Zheng Garden Site Plan

Staff Report

SITE: 143 Lowell Road -- Map 204/Lot 5 -- SP# 13-14

PLAN UNDER REVIEW ENTITLED: “Non-Residential Site Plan Zheng Garden, Map 204 Lot 5, Lowell Rd., Hudson, NH, prepared by Keach-Nordstrom Associates, Inc., dated: 25 August, 2014, last revised 5 November 2014, consisting of Sheets 1 - 15 and Notes 1 – 32 on Sheet 1 (said plans are attached hereto).

SHEET 7 OF 15

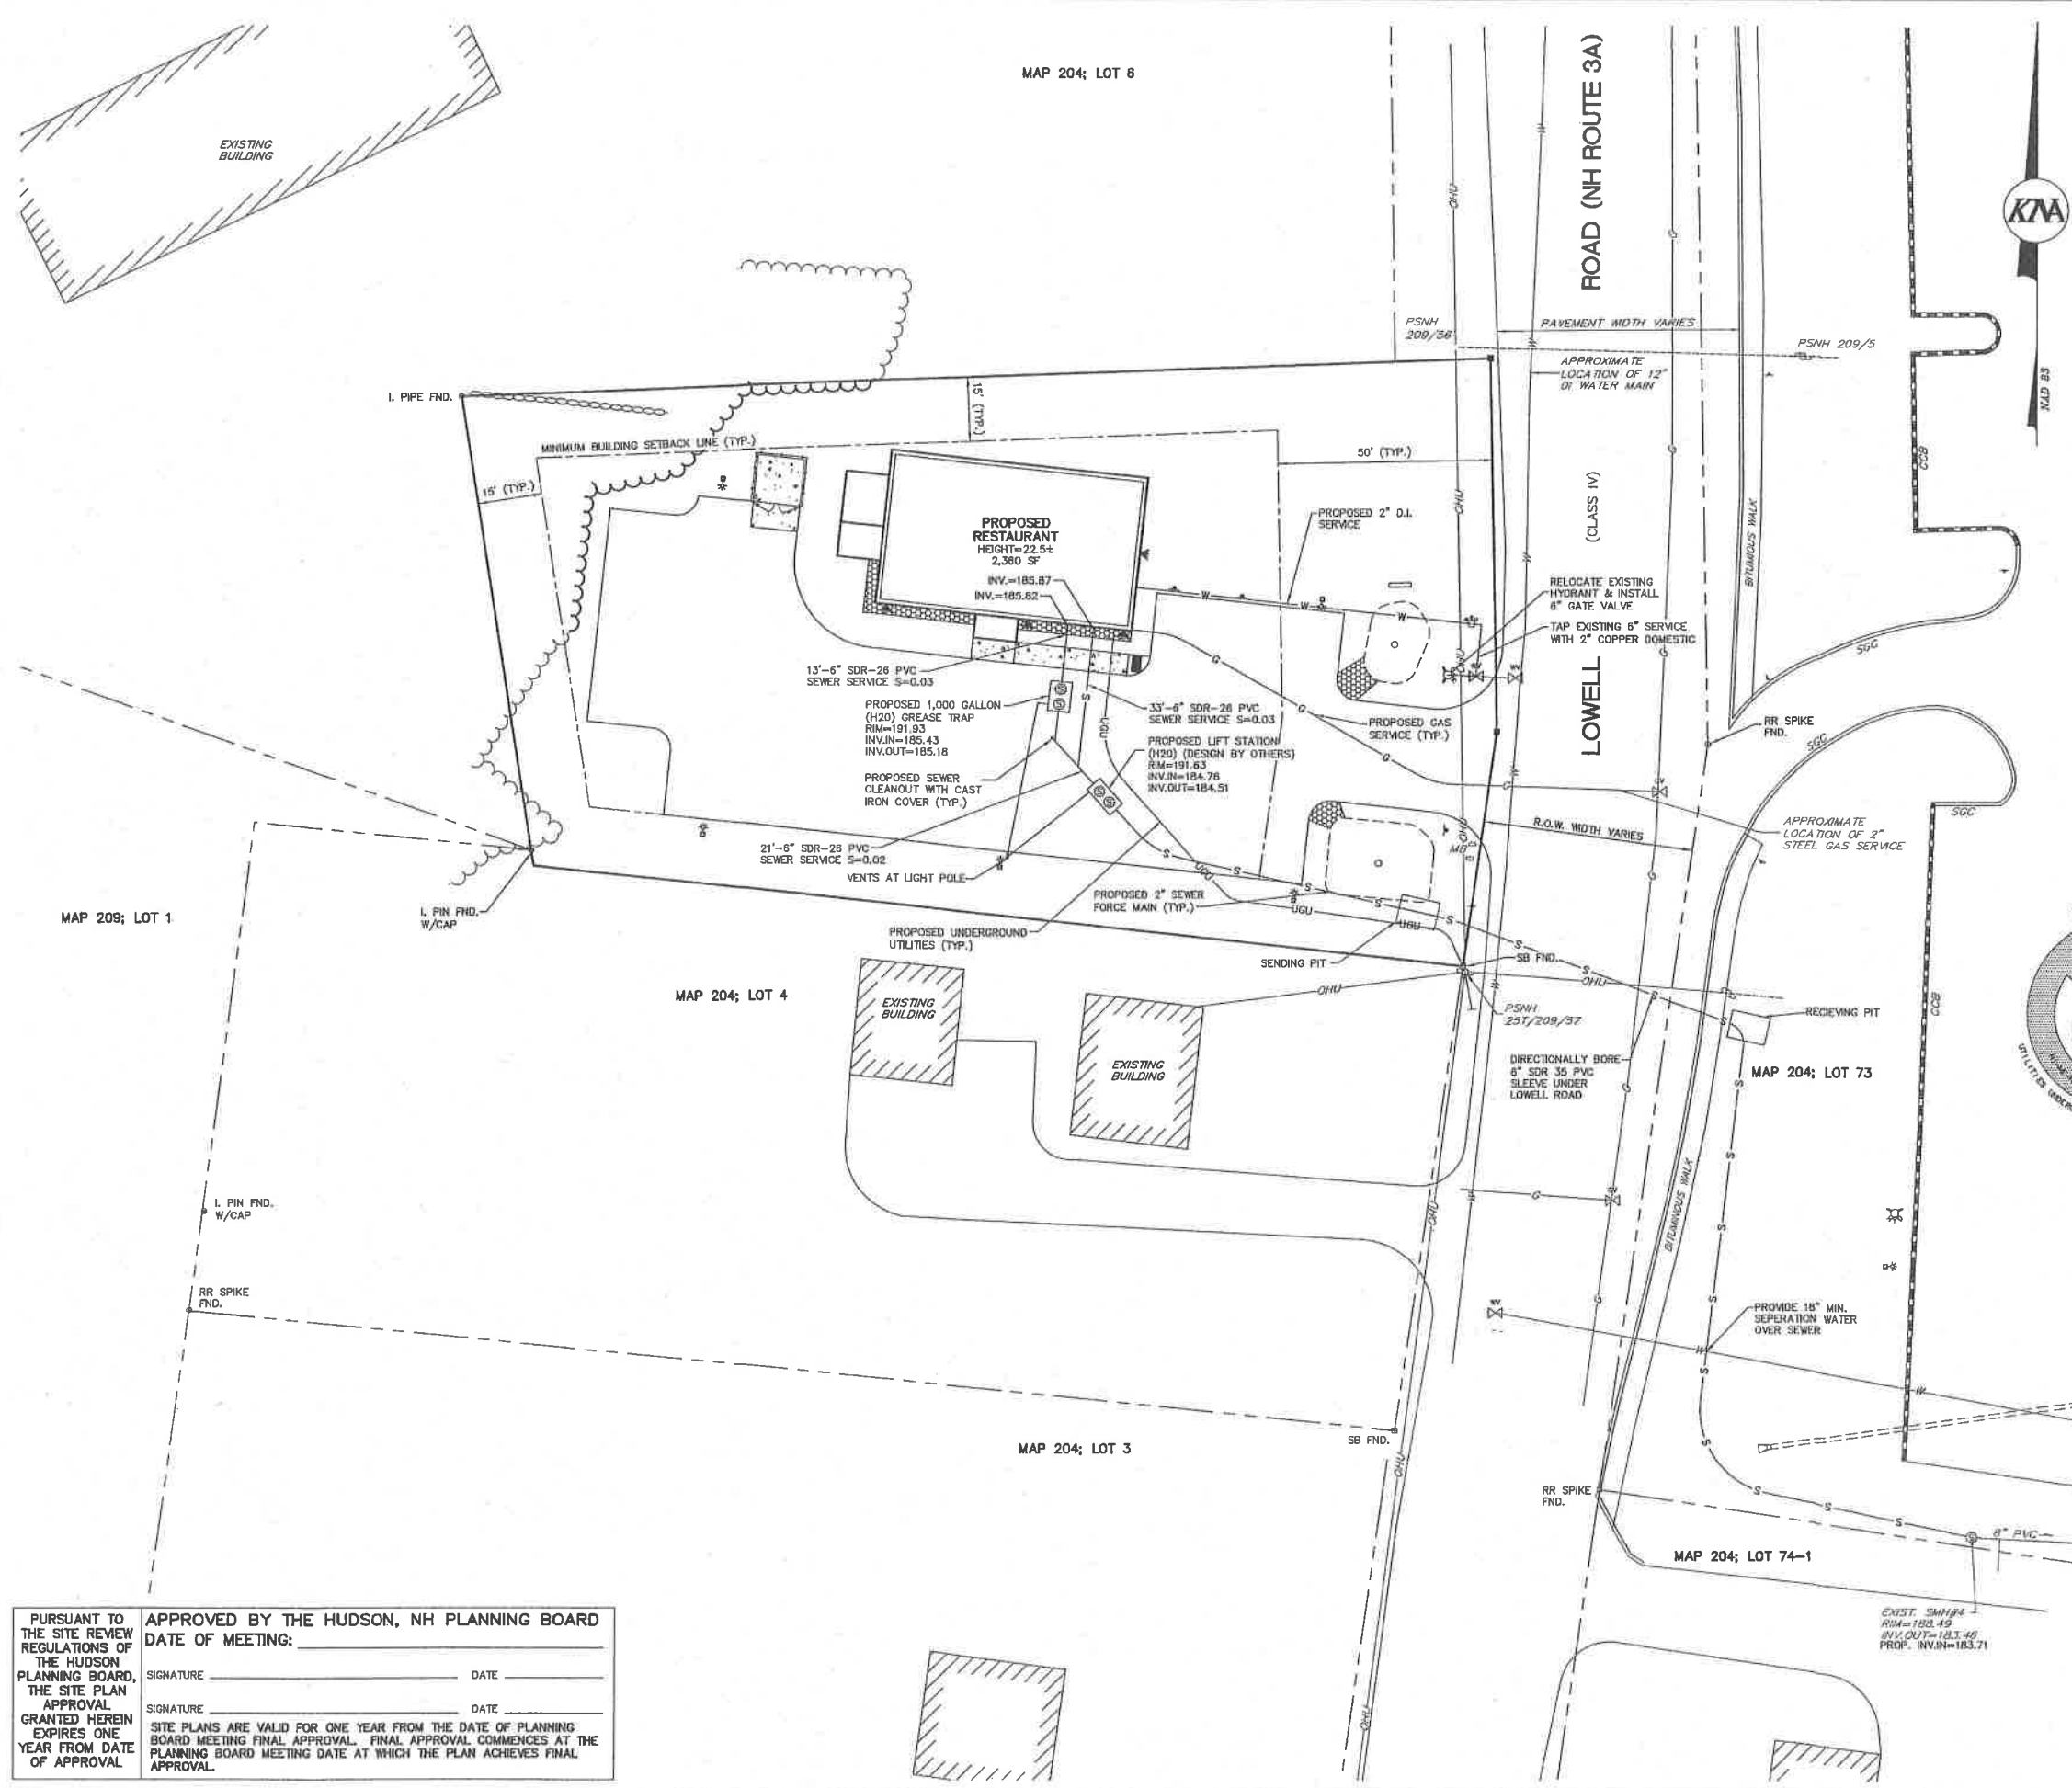
- a. *Former CLD Comment: HR 275-9.E. The applicant is proposing connection to existing public sewer by directional drilling of a force main across Lowell Road. The proposed depth of the force main provides less than six feet of cover which conflicts with details in the plan set, and could also potentially conflict with existing water and gas mains. For sewer and force main construction within the site, the applicant has proposed elevations that conflict with minimum cover amounts shown in construction details. Also, the applicant should note that all components of the existing septic system shall be removed/remediated according to all state and local requirements.*

Current CLD Comment: The applicant has revised the plans and added a detail that shows a depth of six feet. The applicant has noted that final profiles of existing utilities and proposed force main will be submitted to the Hudson Engineering Department prior to construction and have noted on the plans that components of the septic system are to be removed with removal of septic system to be "handled properly." We suggest that the note be expanded to include intended compliance with local, state and federal guidelines and rules.

The details and plans have been revised to show a depth of 6 feet within the site. The proposed force main within Lowell Road will require extensive research. Profiles of the existing utilities and depth of the proposed force main will be submitted to the Hudson Engineering Department prior to the start of construction. Note #6 has been added to sheet 7 regarding the existing septic system.

DATE: AUGUST 25, 2014	SCALE: 1" = 10'
PROJECT NO: 14-0718-1	SHEET 8 OF 15

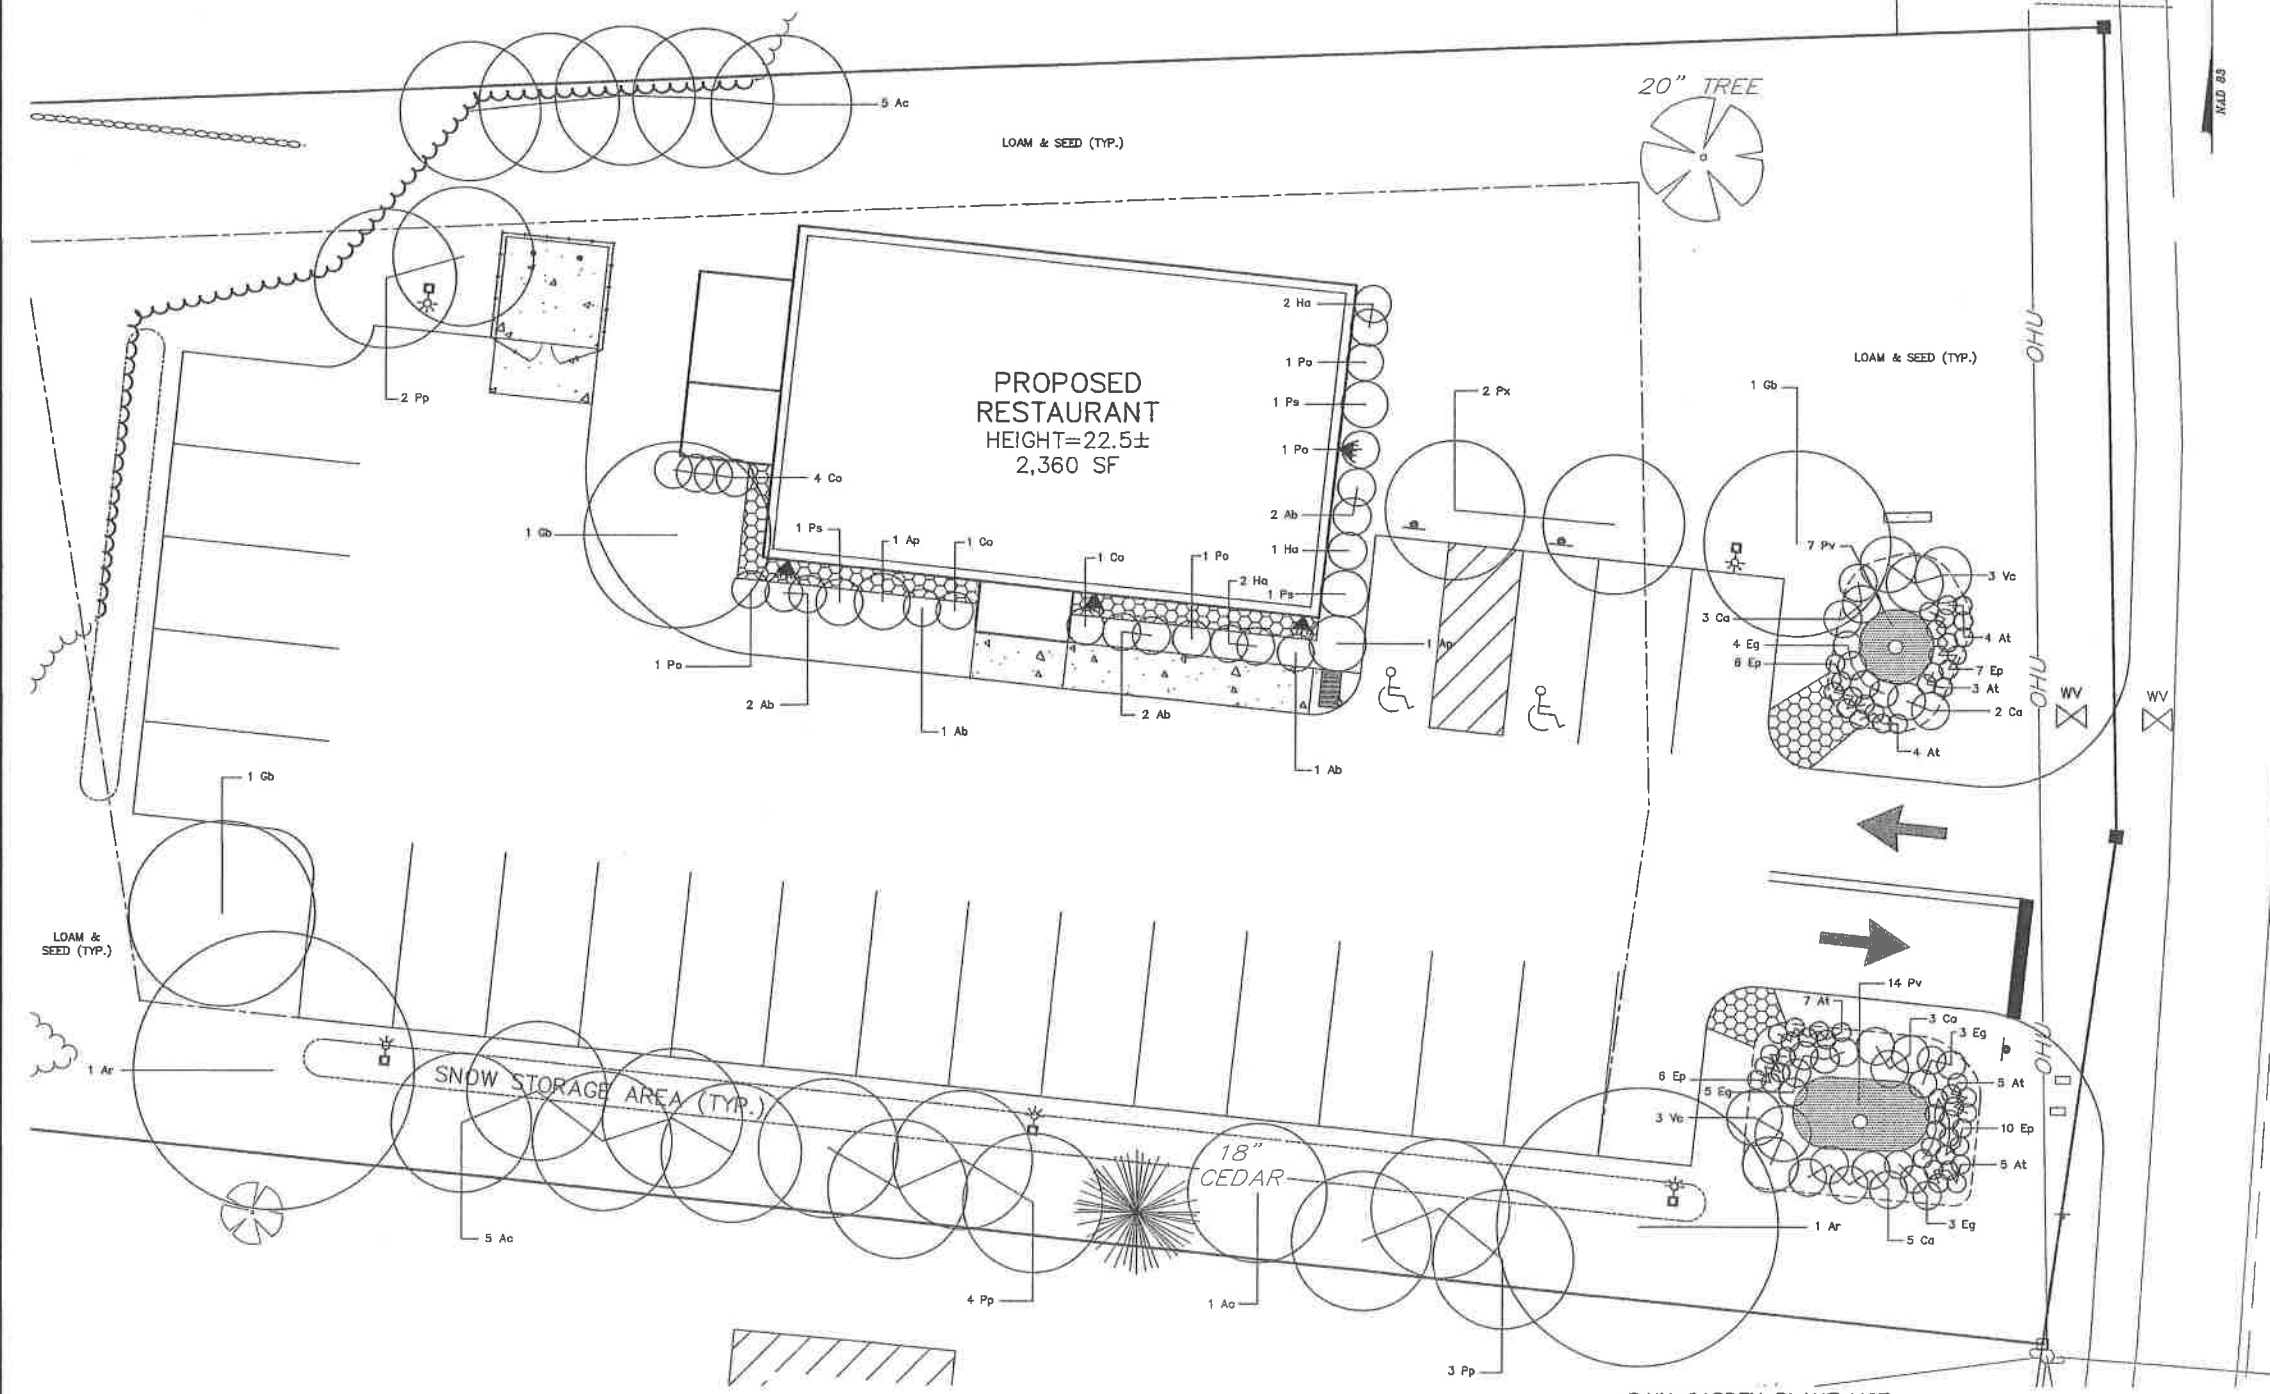
7. Except for the oft sought "Interior Landscaping" waiver request, the site's proposed landscaping complies with §275-6.L. and §275-8.(22) of the board's Site Plan Review regulations, whereby the grass or landscaping area shall be, at minimum, 35 ft. in-width (i.e., from the edge of the ROW into the lot) when the front setback calls for a 50 ft. structural setback. In this regard, Lowell Rd., which is an arterial road requires said 50 ft. front setback. Also, please refer to Sheet 4 of 15, wherein, said 35 ft. grass or landscape area is measured and depicted.

- 7) Onsite landscaping and exterior lighting shall be provided for in accordance with the Sheets 8 & 9 of the Plan.
- 8) Exterior construction activities on the site shall be limited to between 7:00 A.M. and 7:00 P.M. Monday through Saturday. No construction activities shall occur on Sunday.

DATE: AUGUST 25, 2014 SCALE: 1" = 20'
 PROJECT NO: 14-0718-1 SHEET 9 OF 15

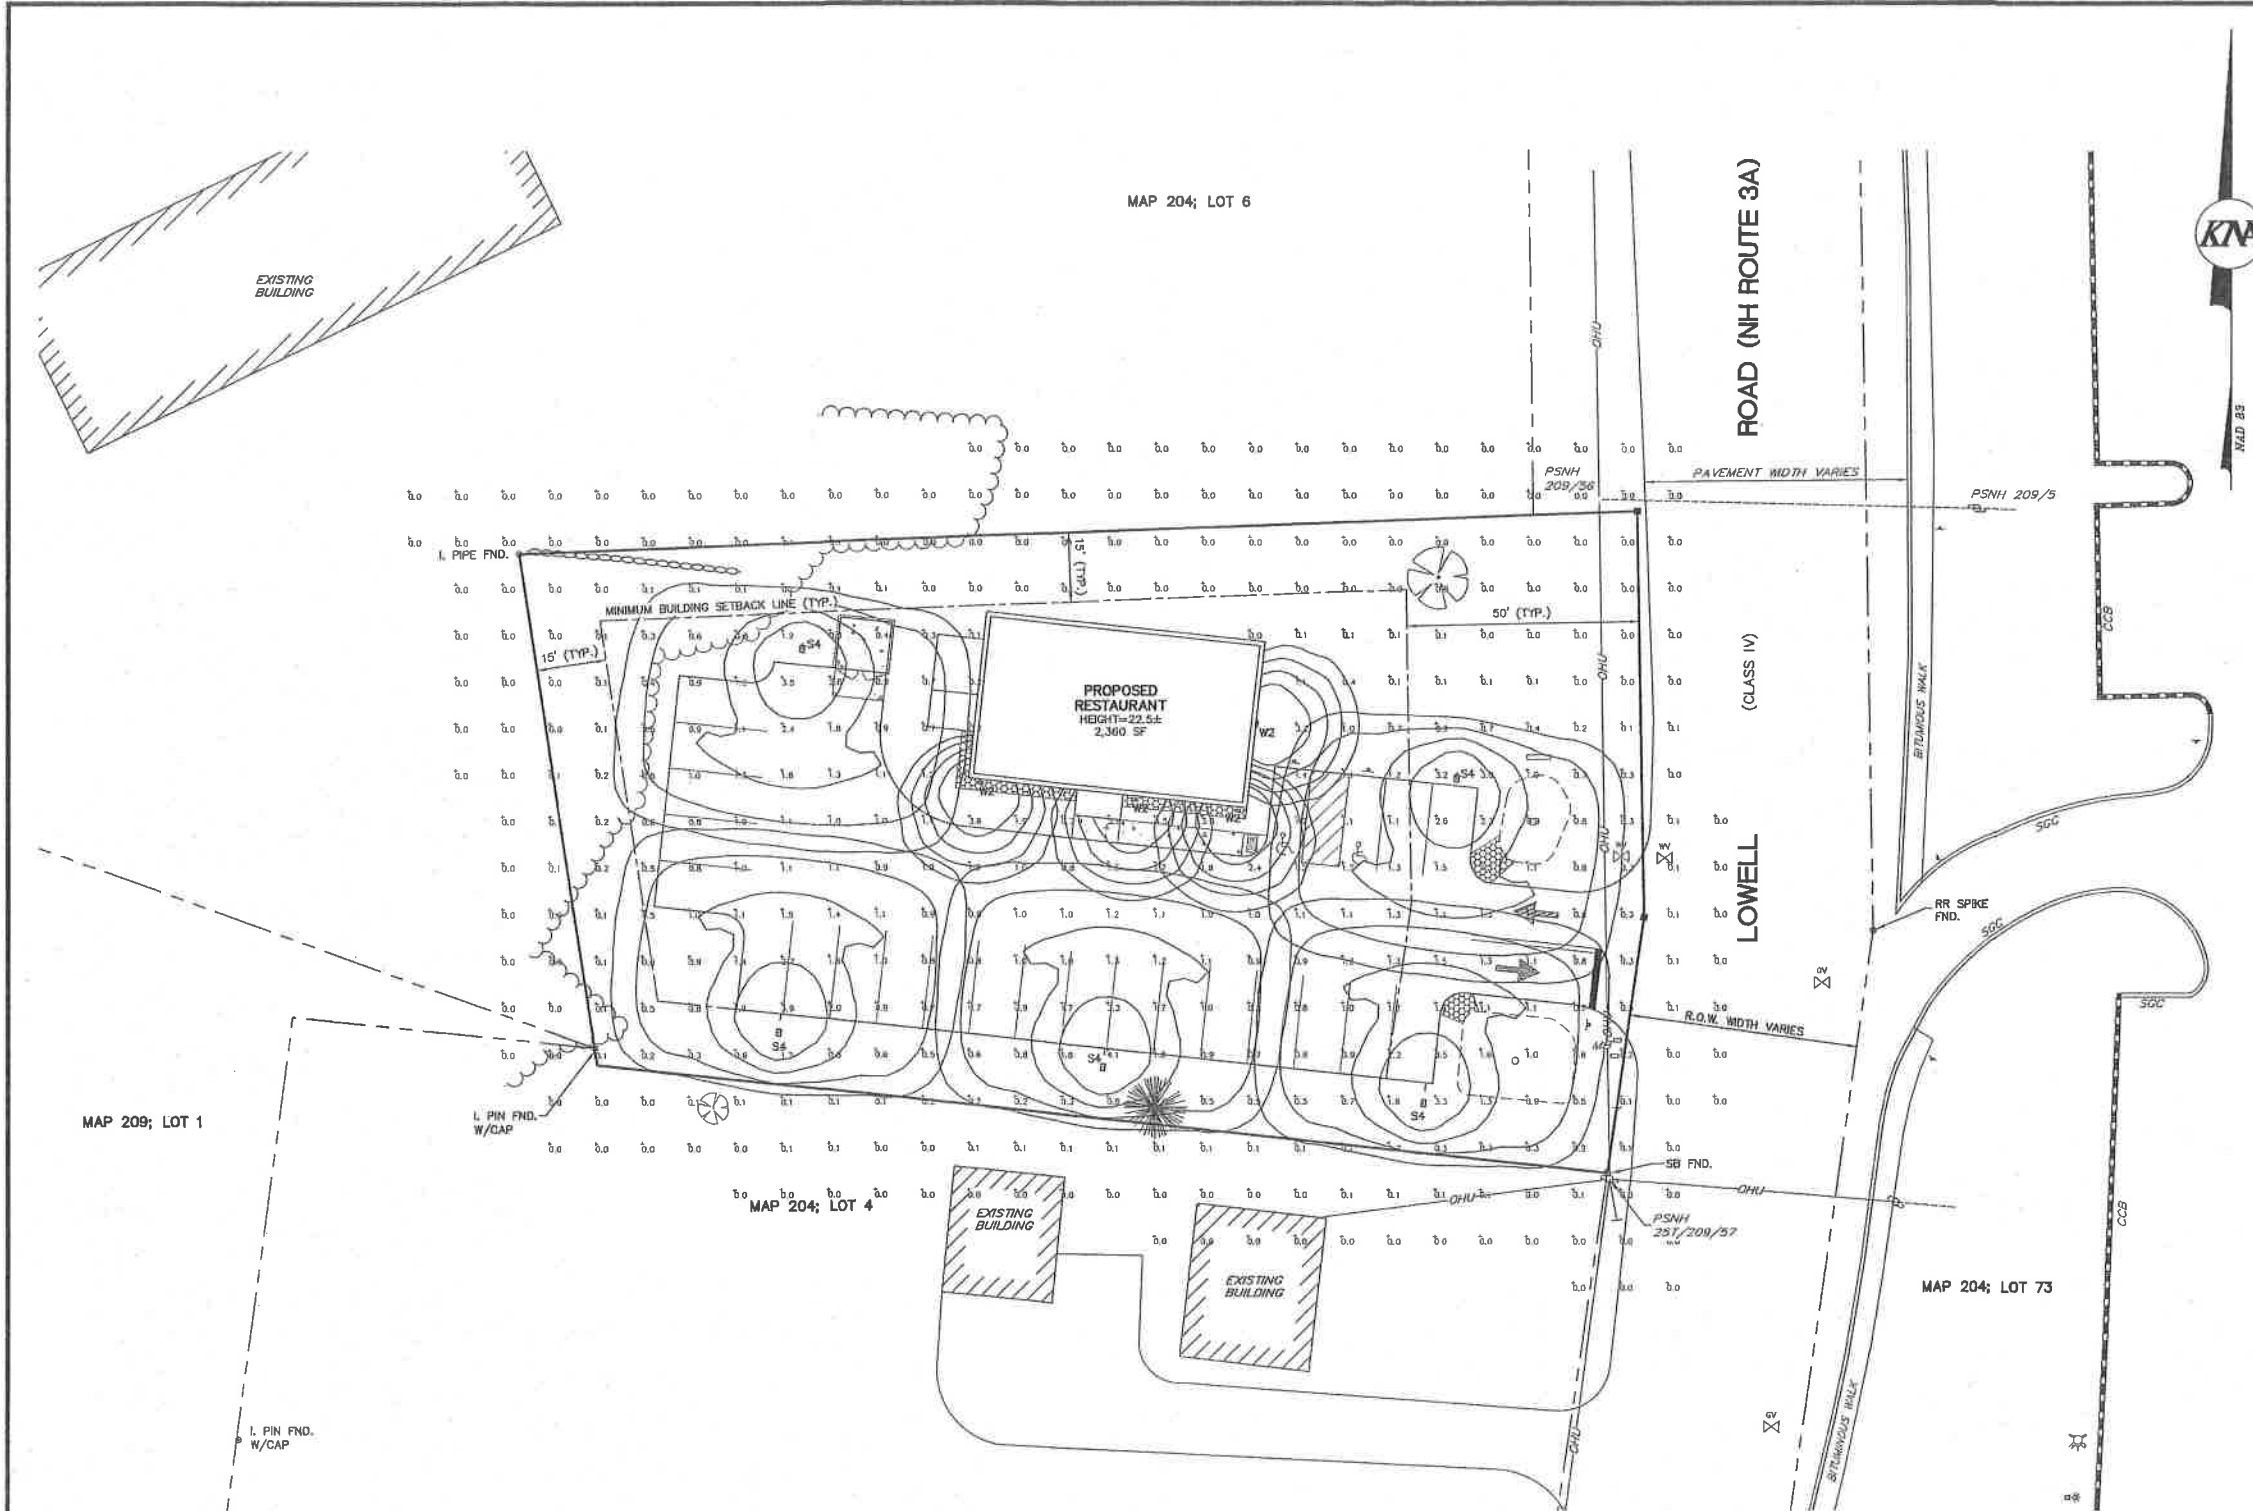
8. Onsite exterior lighting has been provided in accordance with the requirements prescribed in §275-8.(B)(13), and shown on Sheet 9. The proposed exterior lighting is LED, and of course hooded.

TYPICAL RAIN GARDEN SECTION
NOT TO SCALE
JUNE 2012

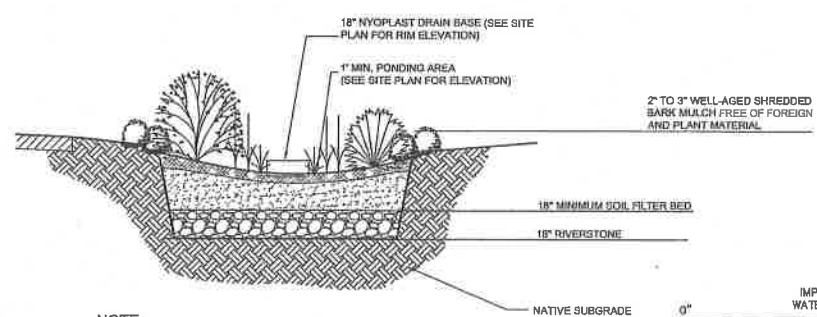
Current CLD Comment: The applicant has provided a Stormwater Management Report. The applicant should provide additional design information for the "Proposed Rain Garden with Nyloplast Basin." The Grading and Drainage Plan illustrates a 188.0 rim elevation, and references the Detail Sheet; while the details on Sheet 12 do not illustrate a depth of basin, where all other dimensions are listed.
